DRB Sketch Plat Meeting (10.21.20)–List of Each Departments comments & Our Response

Project #:PR-2020-00004548

Application #:PS -2020-00098

FINAL PLAT OF LOT 27-A
UNIT 22 VOLCANO CLIFFS SUBDIVISION
BLOCK 6, UNIT 22
SITUATE WITHIN
SECTION 23, T. 11 N., R. 2 E., N.M.P.M.
CITY OF ALBUQUERQUE
BERNALILLO COUNTY, NEW MEXICO
MARCH 2021

**FINAL PLAT OF
LOT 27-A
UNIT 22 VOLCANO CLIFFS SUBDIVISION
BLOCK 6, UNIT 22
SITUATE WITHIN
SECTION 23, T. 11 N., R. 2 E., N.M.P.M.
CITY OF ALBUQUERQUE
BERNALILLO COUNTY, NEW MEXICO
MARCH 2021**

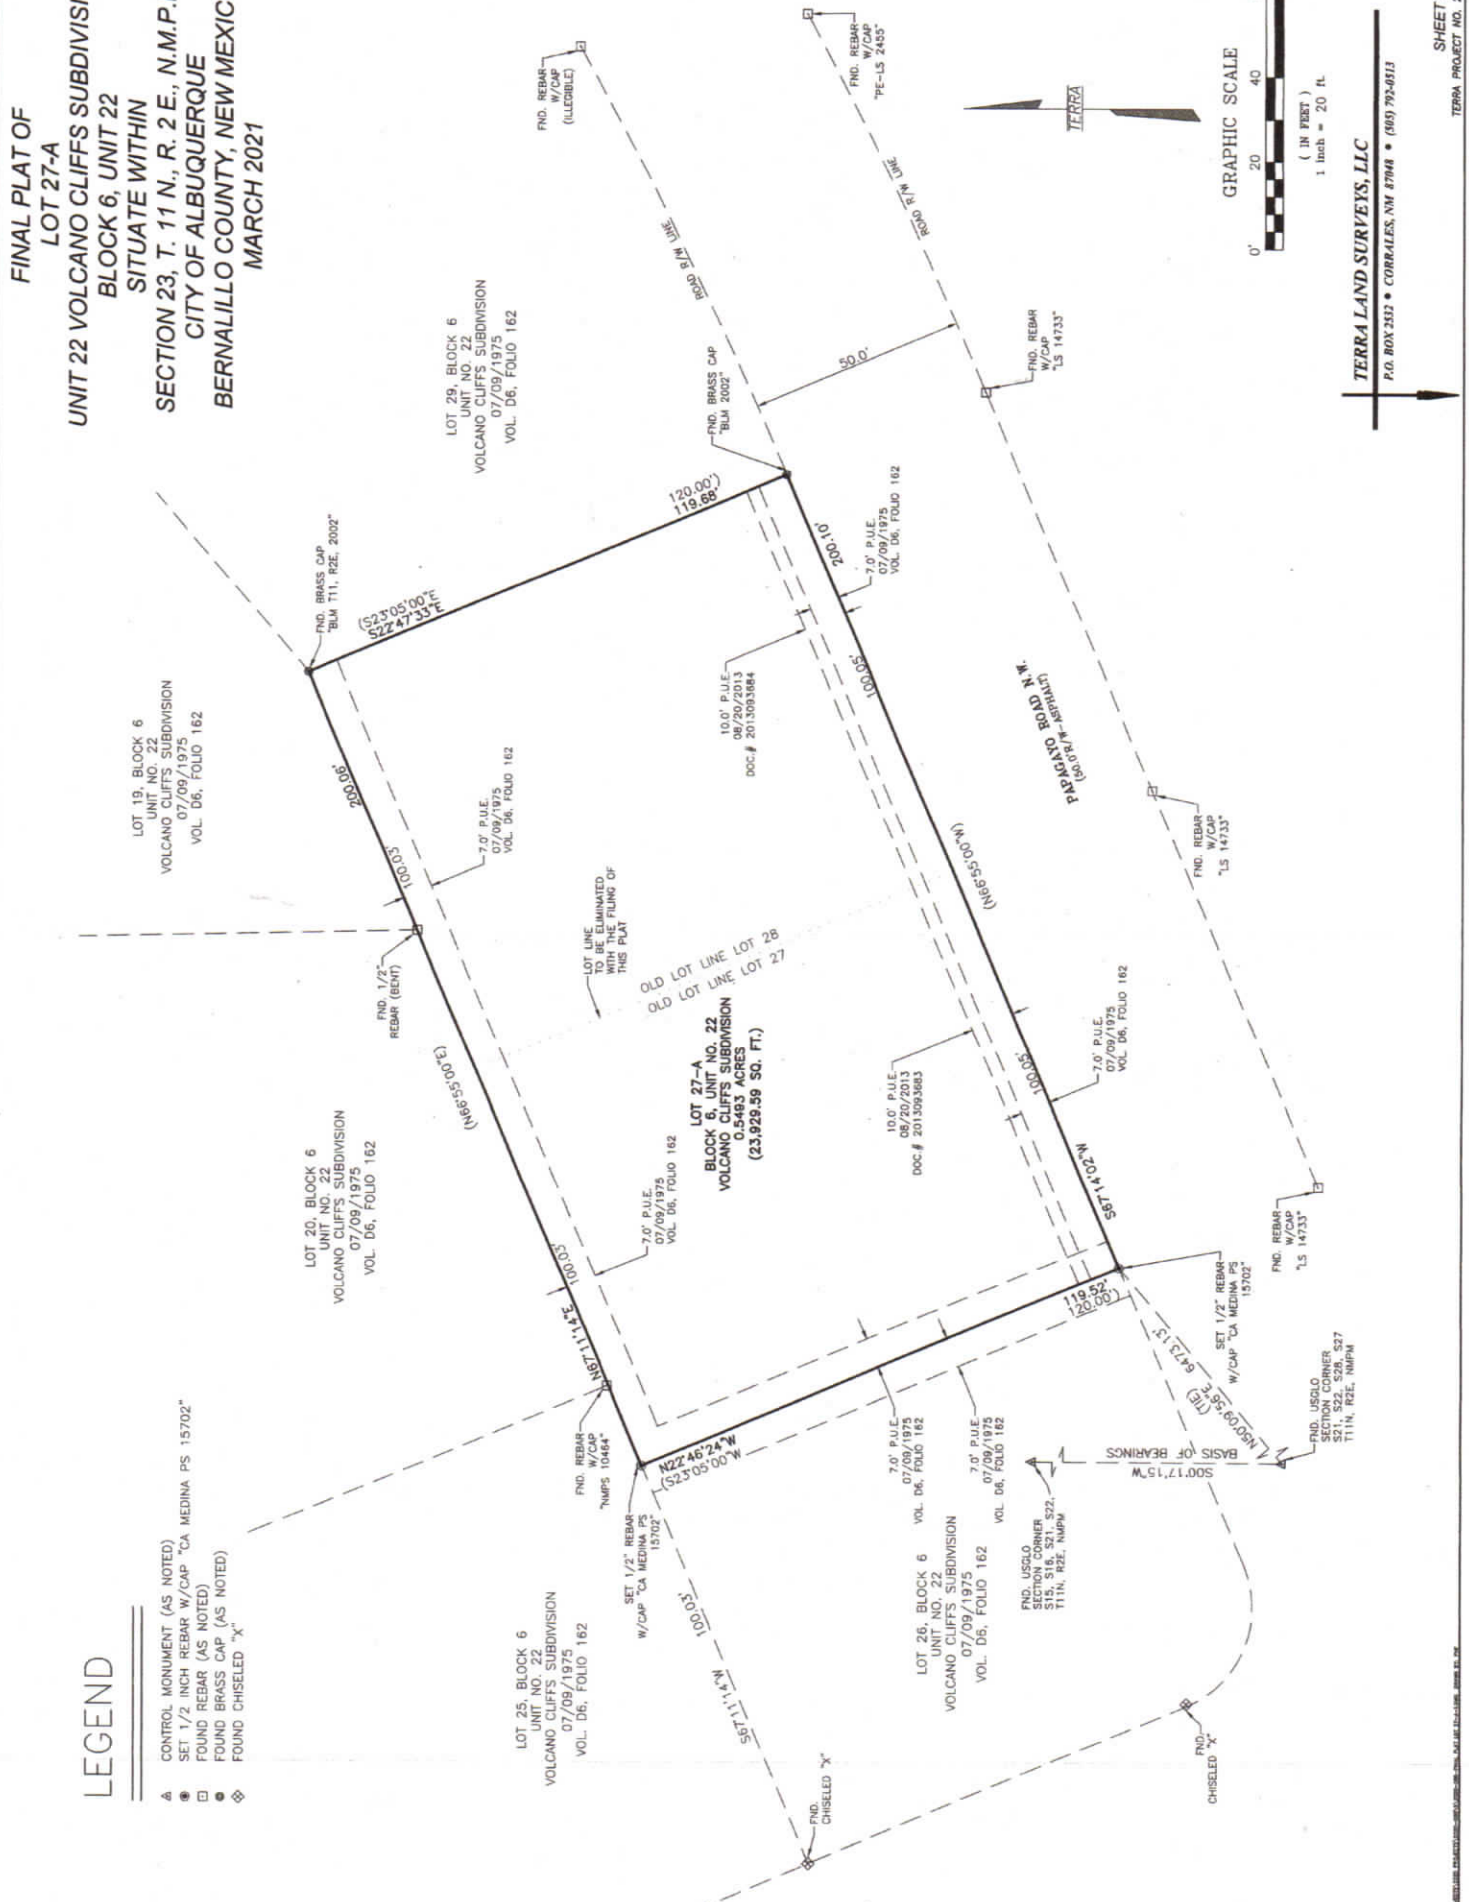
1. Show distance between curb to property line and existing sidewalk width. A minimum 5-foot wide sidewalk is required.

2. The plat does not reflect Papagayo Road right-of-way that continues to the northeast. It appears to be drawn as an easement. Label right-of-way width.

3. The adjacent road should be extended to north end of property including curb and sidewalk.

4. Due to the combination of the temporary cul-de-sac length exceeding over 150 feet in length and the cul-de-sac not meeting standards, seek Fire Marshall Approval to keep current road layout.

Our Response: Yes, information has been provided via email to the Transportation Dept. and noted on Final Plat prepared by Terra Land Survey's, LLC.

Our Response: Information has been provided, and accepted by the Transportation Dept., that clarifies that our street, Papagayo, ends at the cul-de-sac that borders the Monument Land.

Our Response: Related to the road, information has been provided to the Transportation Dept to show that road did not need to be extended. The road ends in a cul-de-sac that is in front of the National Monument Land. Related to the sidewalk, information was provided to the Transportation Dept. and the Transportation Dept. found our explanation for not extending the sidewalk to the end of our lot and around the cul-de-sac was very reasonable. The Transportation Dept. sent an email to DRB and to us with instructions to submit a 'Waiver' to DRB. DRB informed us to wait until after the Variance was approved. **The Waiver Form V2 was accepted on March 15; we are on the DRB Meeting Calendar for March 31st.**

Our Response: Yes, Fire Marshall granted approval and submitted to Transportation Dept. It was noted also that cul-de-sac at end of Papagayo, bordering the Monument Land, is not temporary, it is 'permanent'.
